CITY OF ALBUQUERQUE

RE: **Campbell Compound**
Drainage Report and Grading Plan
Engineer's Stamp Date 9/26/17
Hydrology File: G13D032

DRAINAGE REPORT

**RE: G13D032 - Campbell Compound
Grading Plan & Drainage Report
Zone Atlas Map: G-13**

DETAILS & RETAINING WALL PLAN

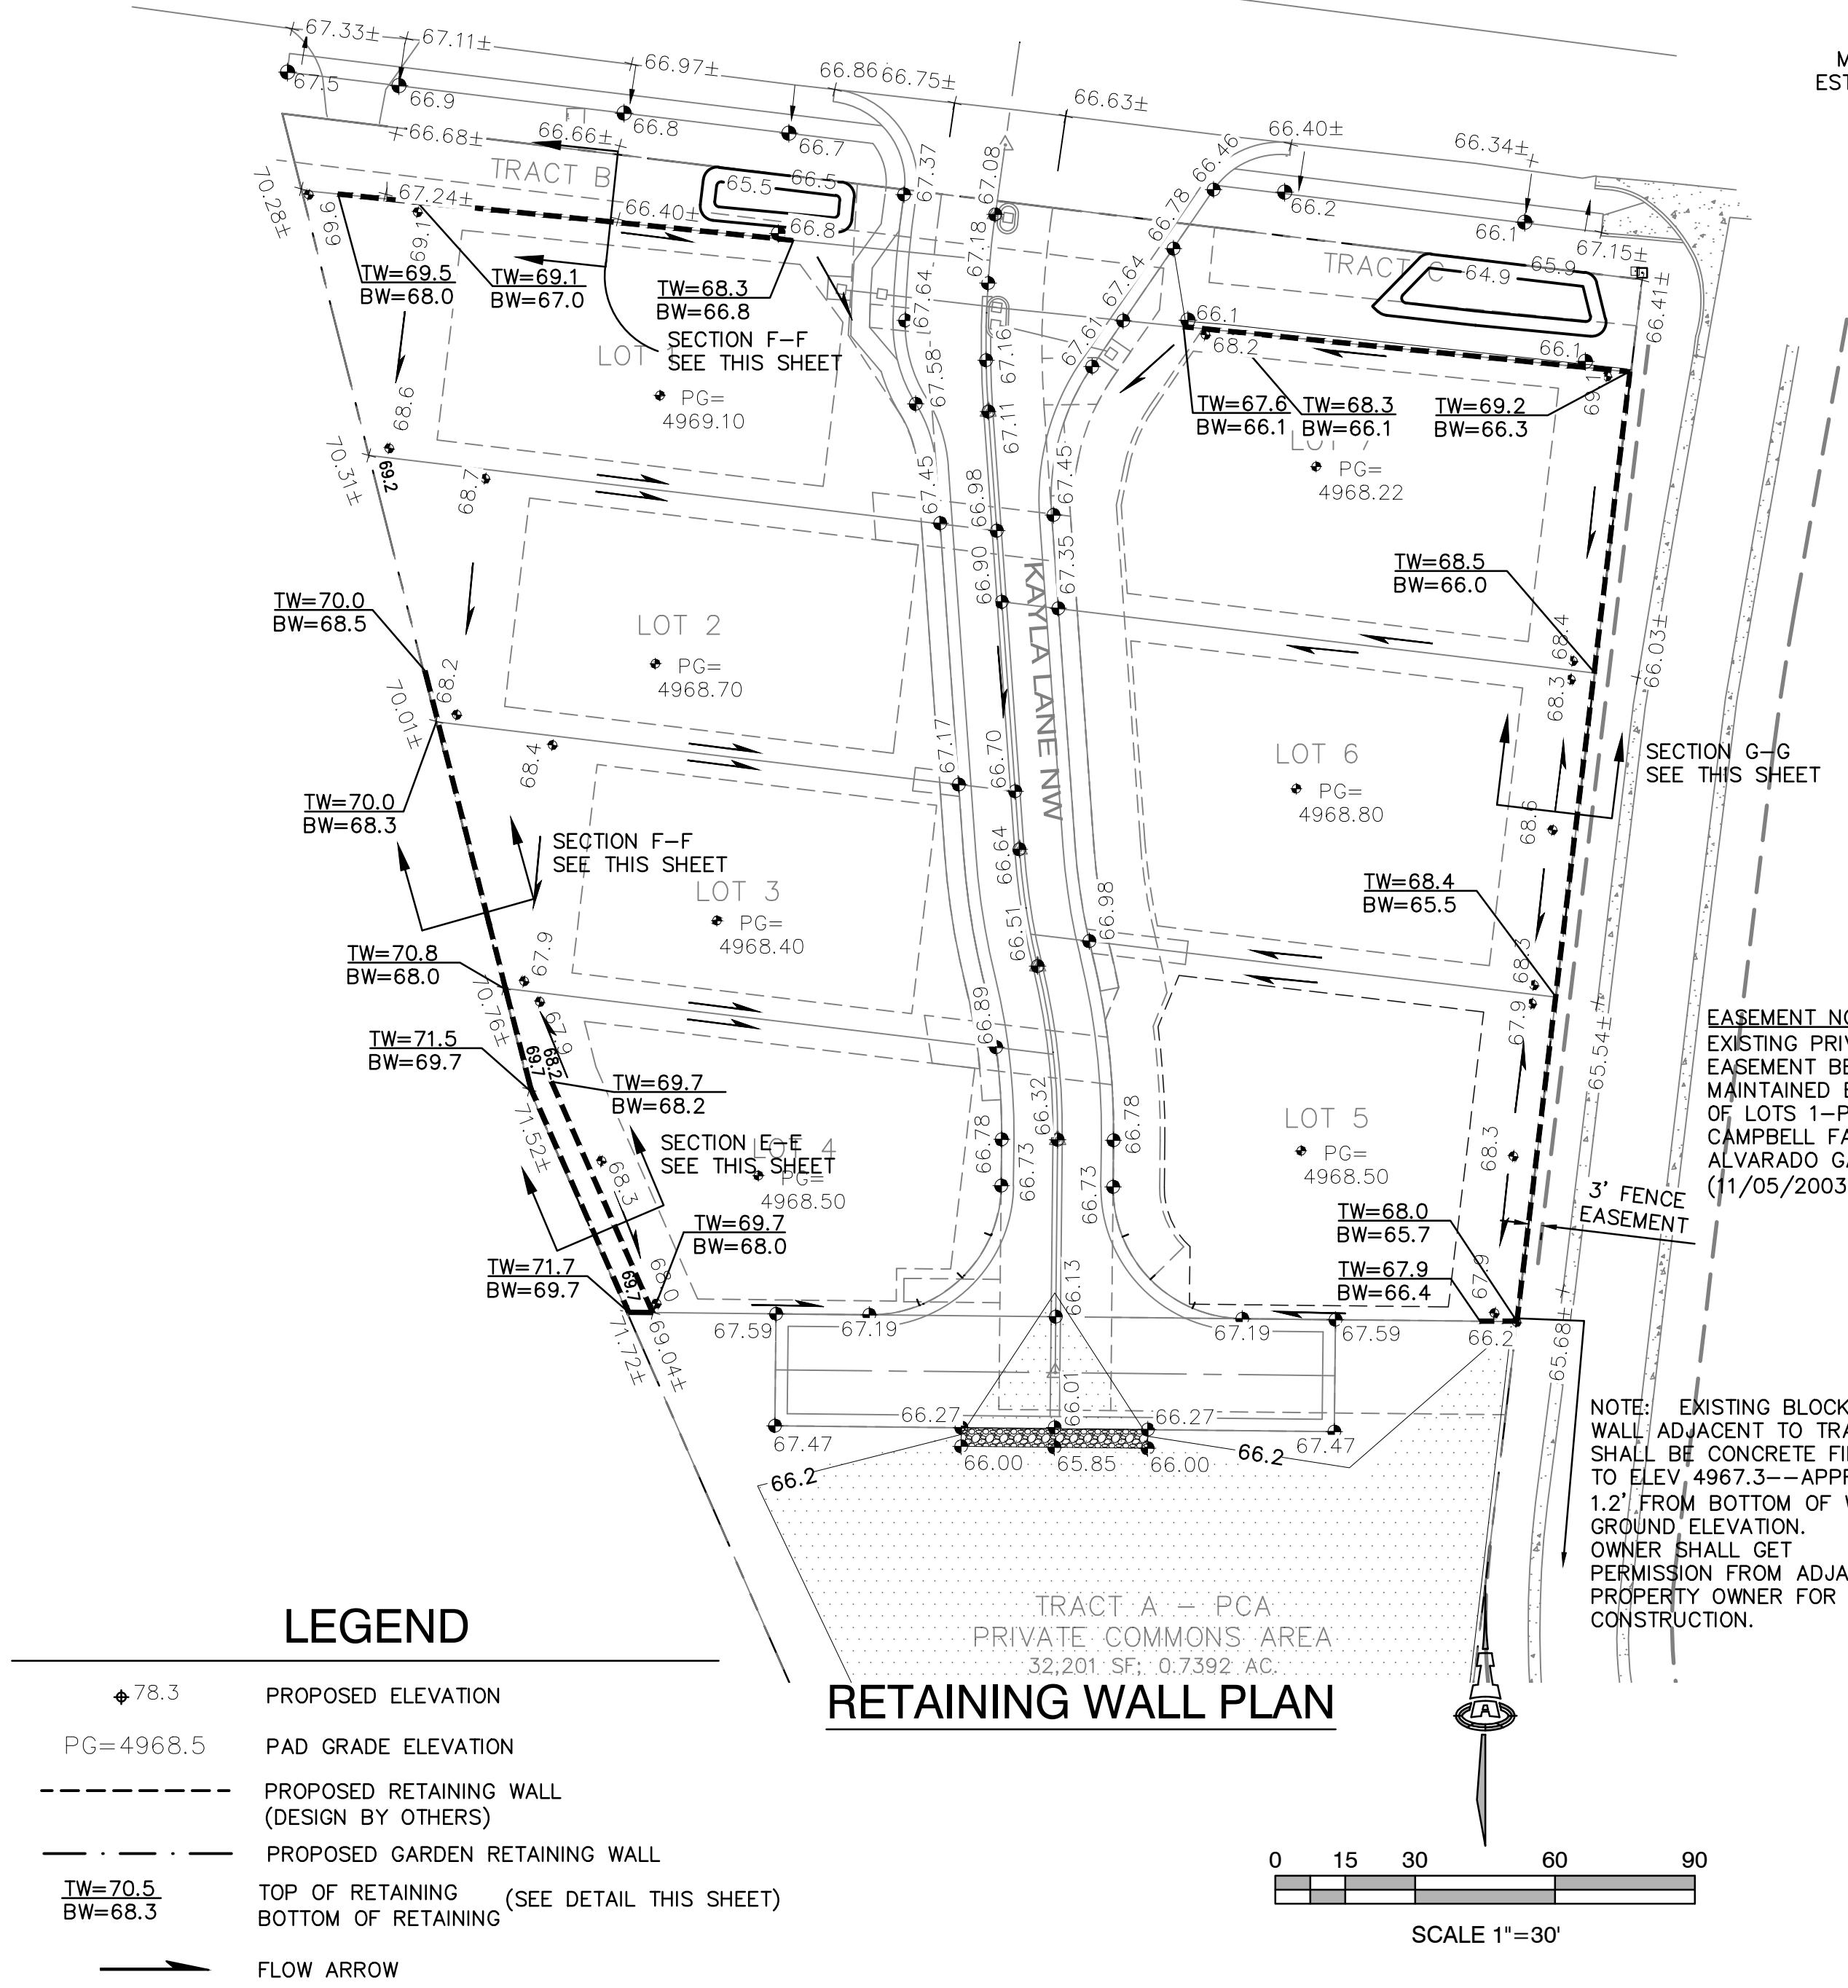
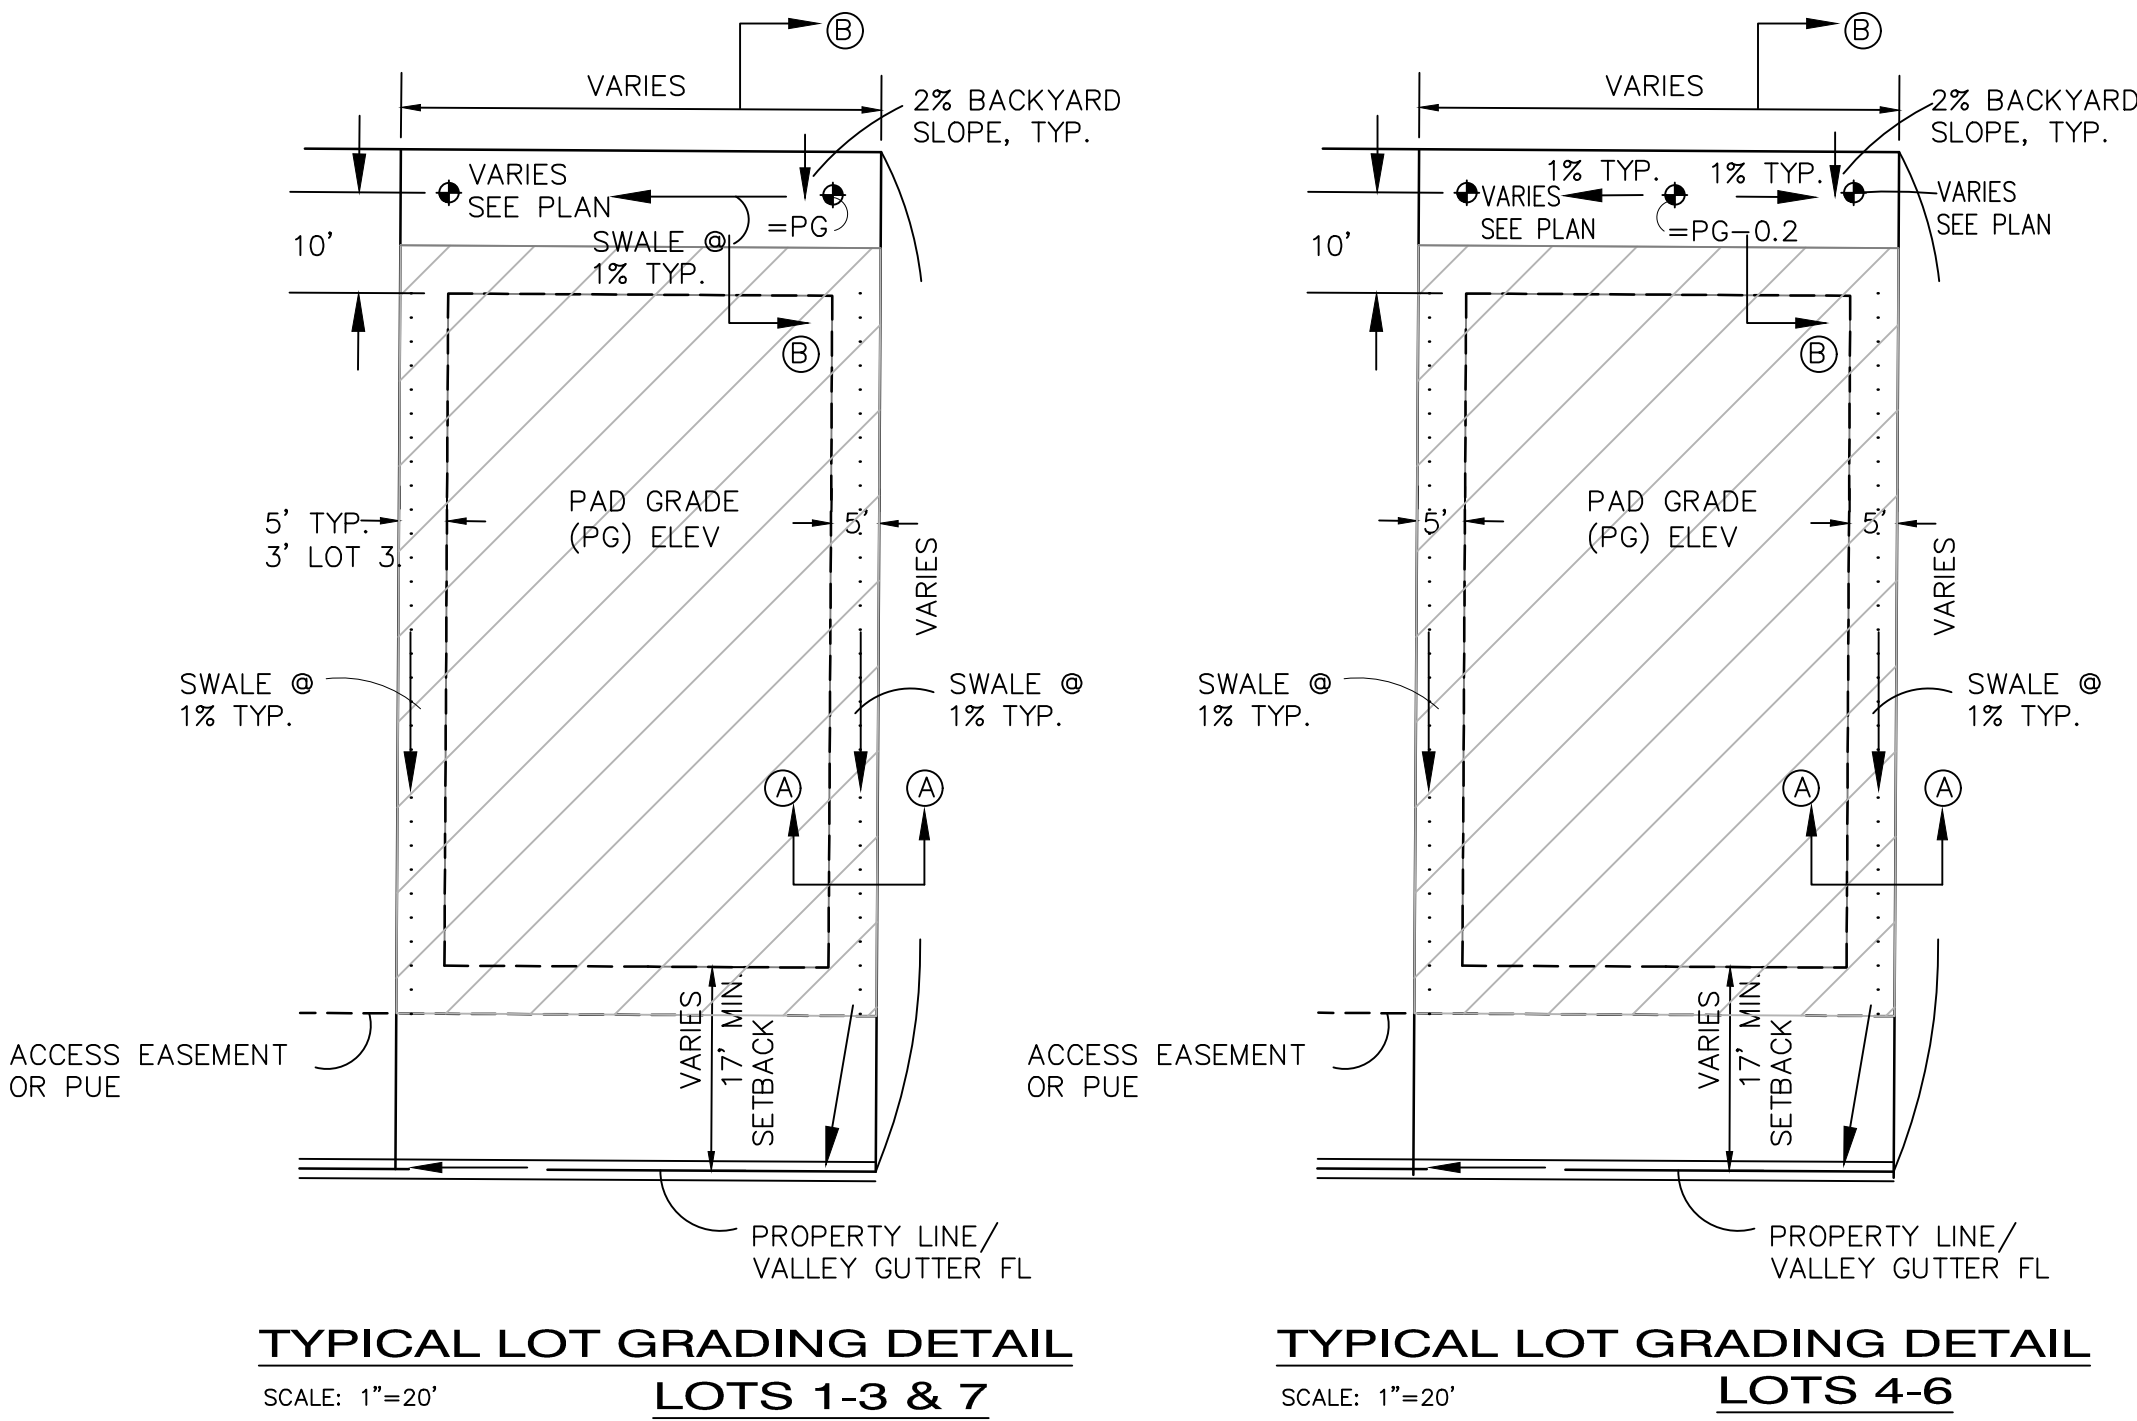
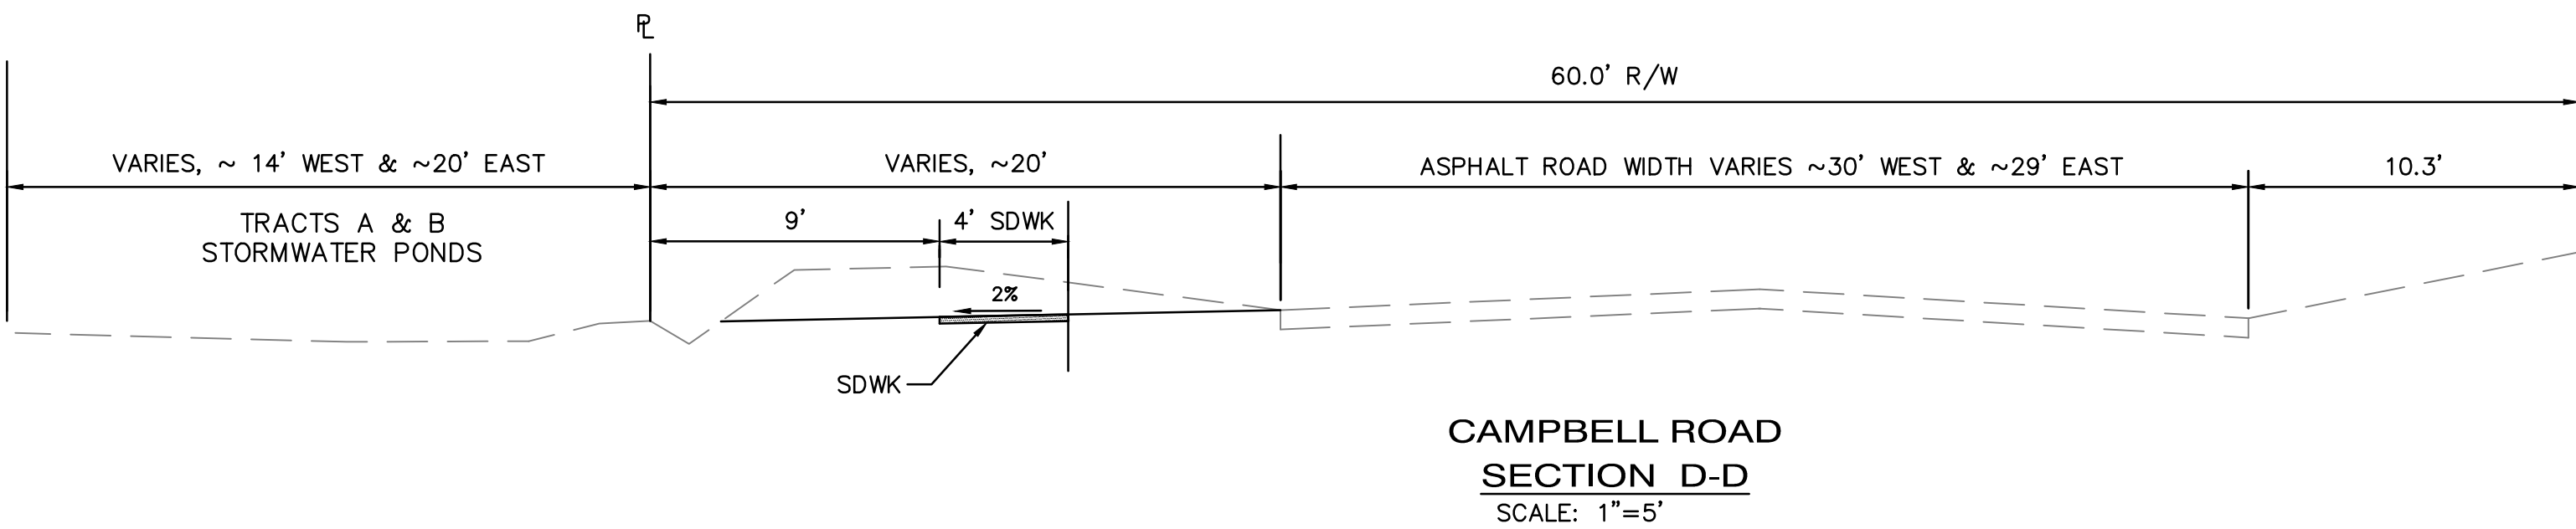
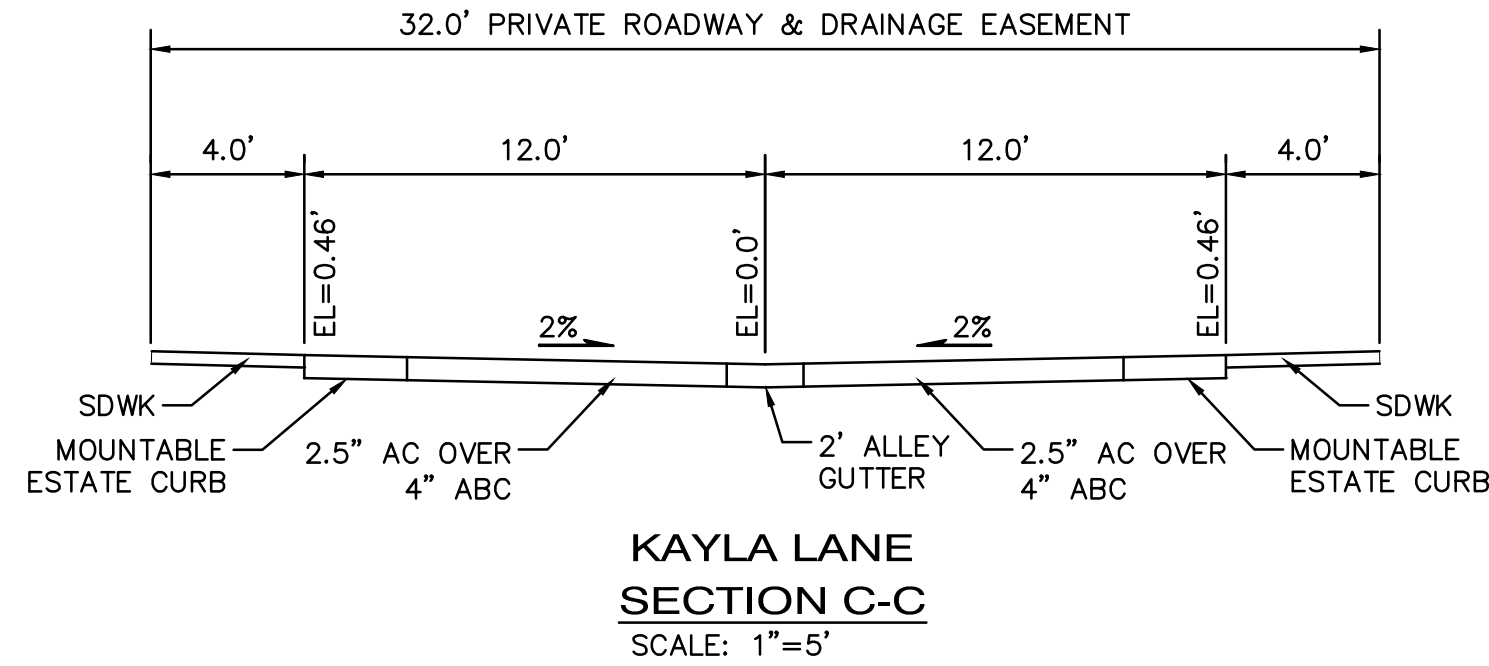
1. Subbasin A needs to include the Campbell Rd half street area and the ponds on tract B & C need to be sized to include this volume.
2. Section E-E on sheet 2/2 shows the retaining wall/privacy wall encroaching across the property line. Correct to show on only Campbell Compound's property.

3. Separate Section F-F into two viewports for the different cases. Clearly show that the footer stays off the adjacent property.
4. Modifying an existing privacy wall into a floodwall is not an acceptable course. If a floodwall is desired, a new one will need to be designed and built (Section Y-Y).

5. Modifying an existing privacy wall into a retaining wall is not an acceptable course. A new wall will need to be designed and built (Section G-G).
6. Written permission from Campbell Farms HOA will need to be obtained, authorizing any modifications to the common wall. If portions of the wall are owned/maintained by Campbell Farms Lot 11, written permission from that homeowner will be needed as well.

7. the rear-yard retaining wall needs to be 4" (minimum) above the high point of the rear-yard swale invert to promote drainage away from the rear wall and to the front yard (Section B-B and G-G).
